BUILDING CODE OF AUSTRALIA COMPLIANCE ASSESSMENT REPORT

PROPOSED RESIDENTIAL DEVELOPMENT

25-27 WARRIEWOOD ROAD, WARRIEWOOD

REPORT NO. ► PROJECT #7733 - REV 1.0

First Floor

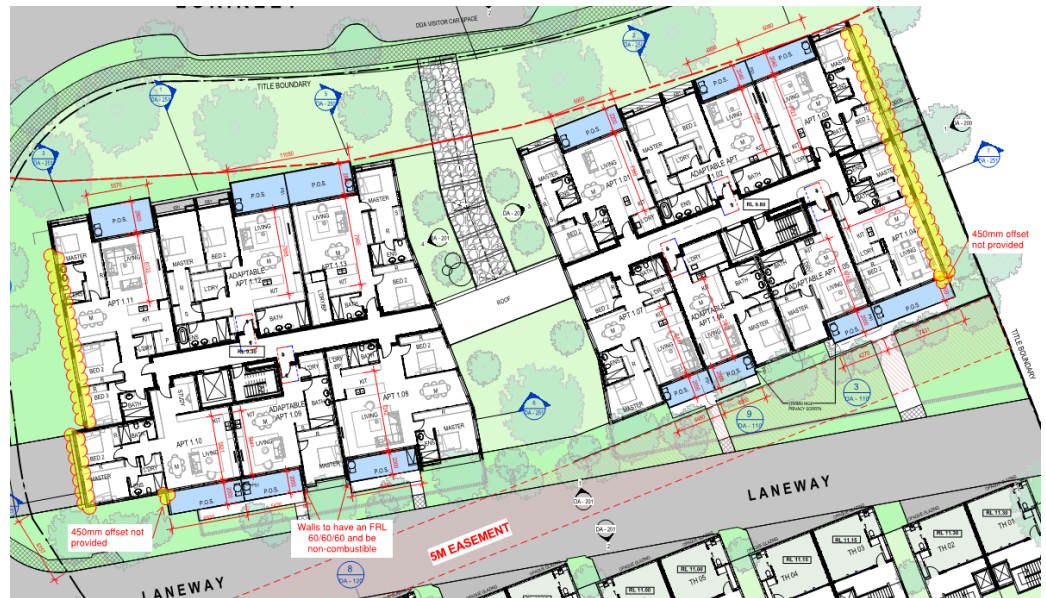
<p>C2.6 Vertical Separation of openings in external walls</p>	<p>There are several openings which require compliant spandrel separation to be provided (see examples below). In these examples, a horizontal spandrel extending a minimum 450mm beyond the opening (offset 450mm from the edge of the balconies) has not been provided. Where a panel wall (not less than 900mm in height, not less than 600mm above the upper surface of the intervening floor and non-combustible with an FRL of not less than 60/60/60) is to be used, the architect is to detail this on the plans at CC stage.</p> <p>Spandrel protection not provided in accordance with Clause C2.6 between the first-floor openings and residential balconies above (second floor) (see examples below and figure C2.6(2) – Section A). This is to be addressed by way of a Performance Solution by a fire engineer.</p>

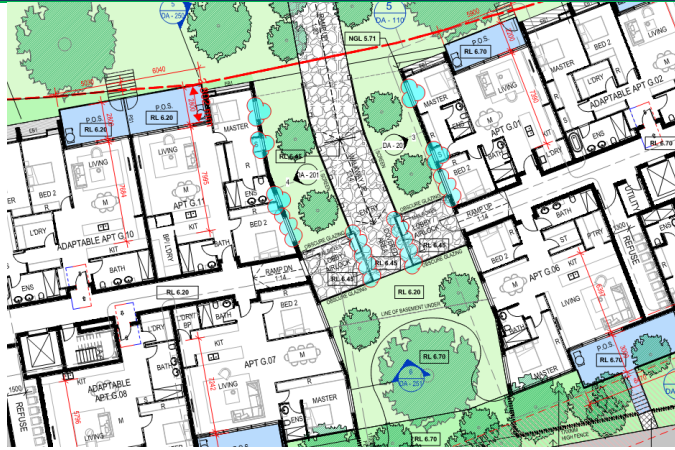
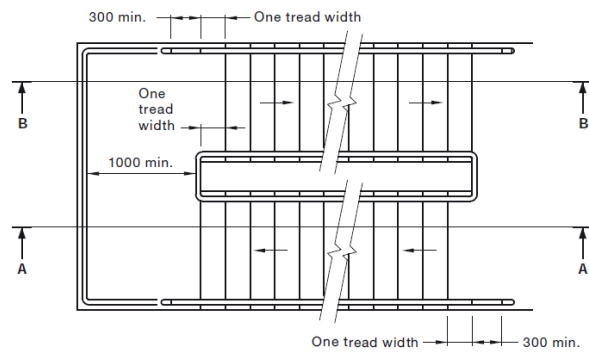
D1.5 Distance Between Alternate Exits	<p>The following areas exceed the maximum distance prescribed to an alternate exit –</p> <ul style="list-style-type: none"> • Basement 01 - Up to 77m through the point of choice to an alternate exit in lieu of 60m from STR08; • Basement 02 – Up to 69m through the point of choice to an alternate exit in lieu of 60m from STR01. <p><i>This may be addressed by a fire engineer by way of a Performance solution at CC stage.</i></p>	
D1.7 Travel via Fire Isolated Stairs	<ul style="list-style-type: none"> ▪ The fire-isolated stairways within North & South building discharge into internally into covered areas that are not open for at least 1/3rd of its perimeter with an unobstructed height of less than 3m and a path of travel from the point of discharge to the road of more than 6m. ▪ Discharge from fire-isolated exits at ground necessitates passing within 6 m of the part of an external wall of the same building, measured horizontally at right angles to the path of travel, as occupants egress into the courtyard and to the western boundary - Lorikeet Grove (see mark-up below).

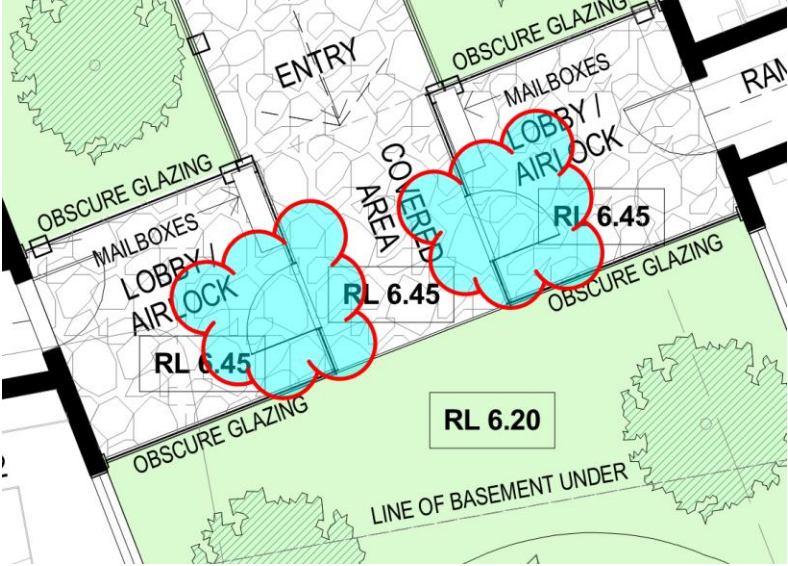
<p>D2.4 Separation of Rising and Descending Stairs</p>	<p>The fire-isolated stairways to the north and south buildings provide direct connection between the basement levels and the residential levels above contrary to this Clause.</p>
<p>D2.17 Handrails</p>	<p>It should be also noted that handrails to fire stairs are required to be of a consistent height throughout the star flights. This is assisted via the provision of a 1 tread offset as per AS 1428.1 – 2009.</p>  <p>(a) Plan DIMENSIONS IN MILLIMETRES</p> <p>FIGURE 28 (in part) HANDRAILS TO STAIRS WITH INTERMEDIATE LANDINGS</p>
<p>D2.20 Swinging Doors</p>	<p>The doorways discharging from the lobby/ airlock on the ground floor are to swing in the direction of egress.</p>

First Floor

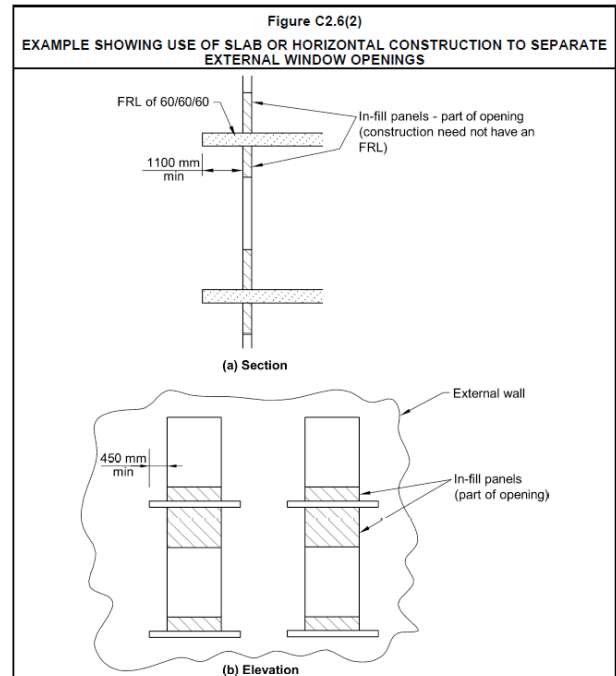
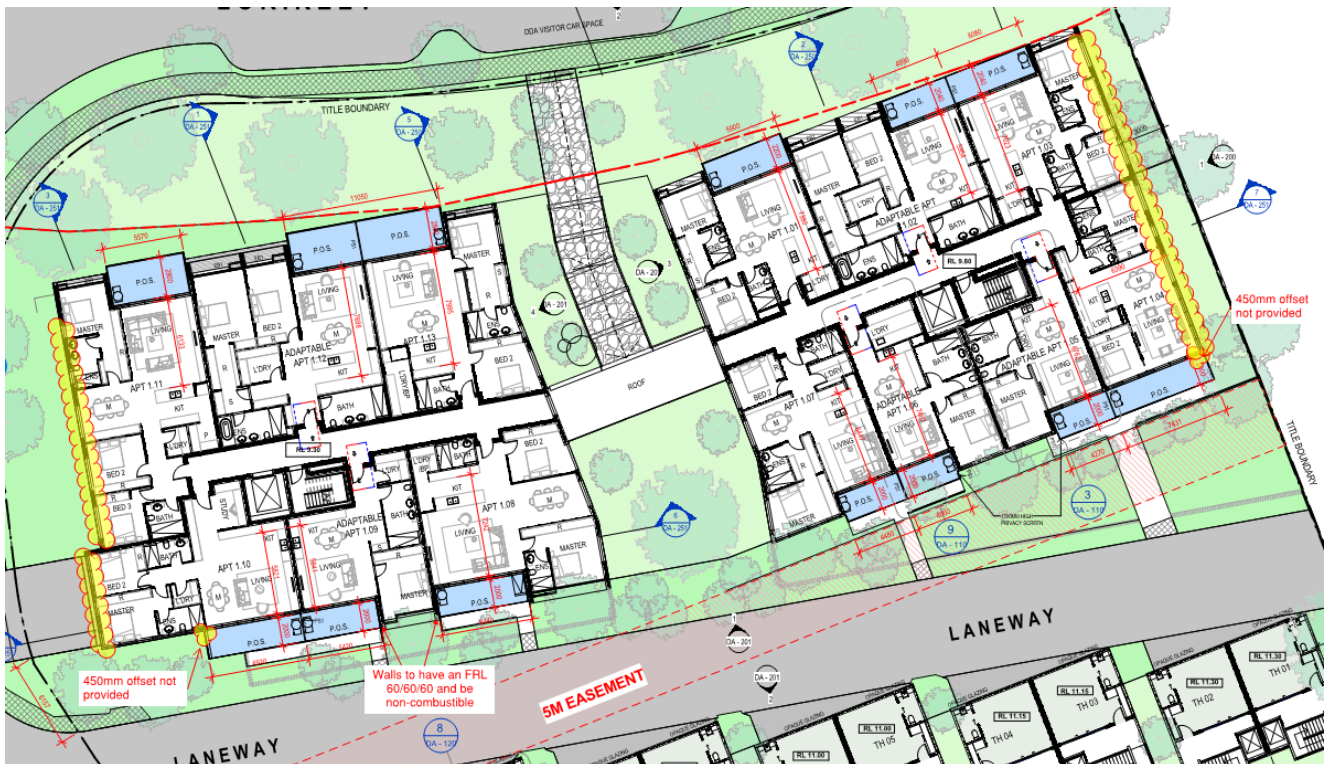
Details of compliant spandrel separation must be provided.

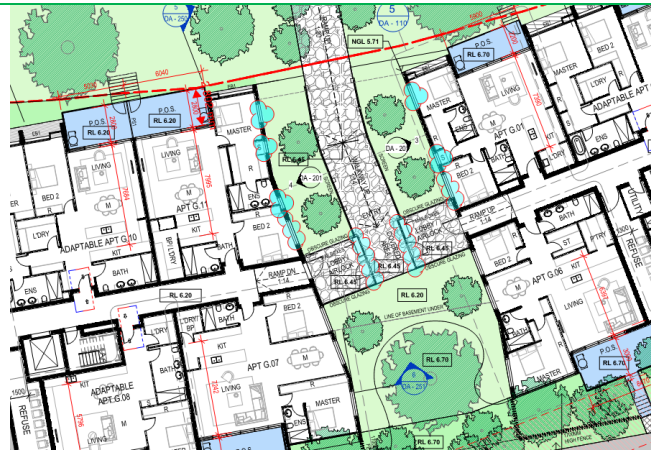
D1.7		X		<p><u>Compliance issues:</u></p> <ul style="list-style-type: none"> ▪ The fire-isolated stairways within North & South building discharge into internally into covered areas that are not open for at least 1/3rd of its perimeter with an unobstructed height of less than 3m and a path of travel from the point of discharge to the road of more than 6m. ▪ Discharge from fire-isolated exits at ground necessitates passing within 6 m of the part of an external wall of the same building, measured horizontally at right angles to the path of travel, as occupants egress into the courtyard and to the western boundary - Lorikeet Grove (see mark-up below).

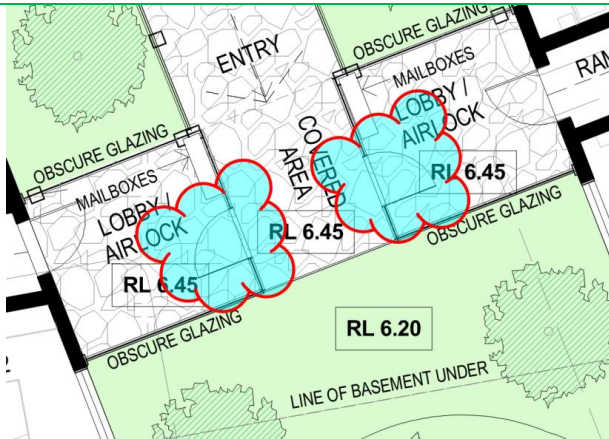
<p>D2.18 Fixed Platforms, walkways and ladders</p>			<p>X</p>	<p>Plant areas may be accessed via stairs and ladders compliant with AS 1657-2013.</p> <p><i>Details demonstrating compliance with this clause must be incorporated into the construction certificate plans / specification.</i></p>
<p>D2.19 Doorways & Doors</p>	<p>X</p>			<p>Complies.</p>
<p>D2.20 Swinging Doors</p>		<p>X</p>		<p><u>Compliance issue:</u> The doorways discharging from the lobby/airlock on the ground floor are to swing in the direction of egress.</p>
